ECE/TRANS/WP.29/GRE/2009/30
16 January 2009

Proposal for draft amendments to Regulation No. 87
(Daytime running lamps)

Proposal for Supplement 15 to Regulation No. 87

Submitted by the expert from Germany */

Figure 1

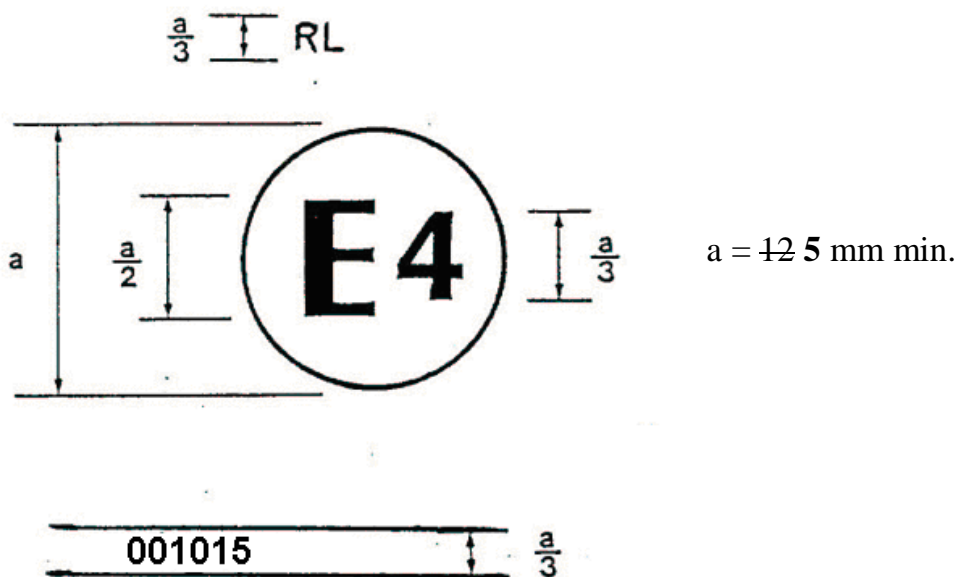
The text reproduced below was prepared by the expert from Germany in order to amend the text of Annex 2 of Regulation No. 87 regarding the size of the approval mark. The modification to the current text of the Regulation, including Supplement 14 to the Regulation, is marked in strikethrough and bold characters.

The amendment in this proposal is intended to align the provisions regarding the size of the approval mark with other existing regulations. In these regulations (e.g. R 6, R 7, R 38, ...), a size of 5 mm for the approval mark is regarded sufficient.

Taking into account that, recently, the apparent surface of the daytime running lamp was reduced from 40 cm² to 25 cm², the still existing "big" approval mark covers a rather large area of the lens.
